Access Compliance Report

Public Rights-of-Way (Curb Ramps)

Intersection ID: 48283	Main Street: MEADOWMONT_VIEW_DR	Cross Street: MEADOWMONT_VIEW_DR	Location: NW
ADA ID: D0F6CDFD87B1	Ramp Type: Perp	Initial Pass/Fail: Fail	Overall Compliance: No
Severity Score: 12.5			
Codes/Mitigation Info/Possible Solution		Field Measurements/Component Compliance

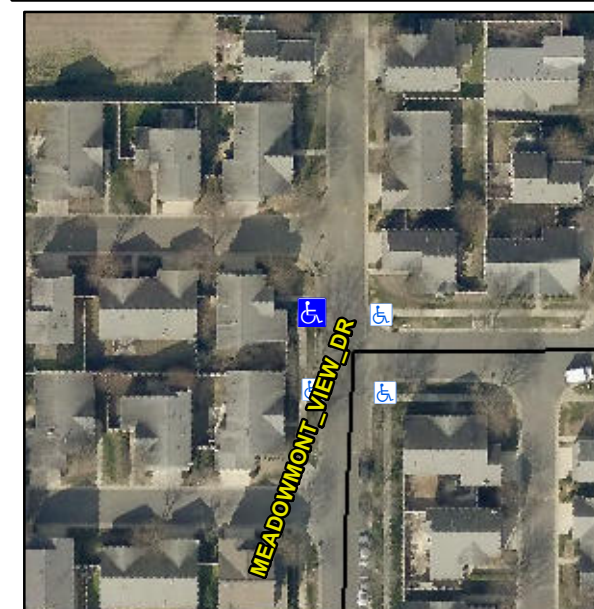
Not Found, R304.2.2

Compliance	Description	Data	Compliance	Description	Data
N/A	Ramp Length (in)	70.0	No	Ramp Slope (%)	11.3
Yes	Ramp Width (in)	48.0	Yes	Ramp XSlope (%)	0.8
N/A	Flare Type LT	N/A	N/A	Flare Type RT	N/A
N/A	Flare Slope LT (%)	N/A	N/A	Flare Slope RT (%)	N/A
N/A	Flare Traversable LT?	N/A	N/A	Flare Traversable RT?	N/A
N/A	Landing Length (in)	N/A	N/A	DWS Provided?	N/A
N/A	Landing Width (in)	N/A	N/A	DWS Contrast?	N/A
N/A	Landing Slope (%)	N/A	N/A	DWS Length (in)	N/A
N/A	Landing X Slope (%)	N/A	N/A	DWS Full Width?	N/A
N/A	Landing Curb? (Y/N)	N/A	N/A	DWS Offset (in)	N/A
N/A	Shared Landing?	N/A			
N/A	Gutter Ponding?	N/A	N/A	Gutter Slope (%)	N/A
N/A	Gutter Lip Ht (in)	N/A	N/A	Gutter X Slope (%)	N/A
N/A	Painted X Walk1?	No	N/A	Painted X Walk2?	N/A
	X Walk 1 Direction	To E		X Walk 2 Direction	N/A
N/A	X Walk 1 Width (in)	N/A	N/A	X Walk 2 Width (in)	N/A
	X Walk 1 Slope (%)	0.5		X Walk 2 Slope (%)	N/A
	X Walk 1 X Slope (%)	0.0		X Walk 2 X Slope (%)	N/A

Remove & Replace Entire Ramp.
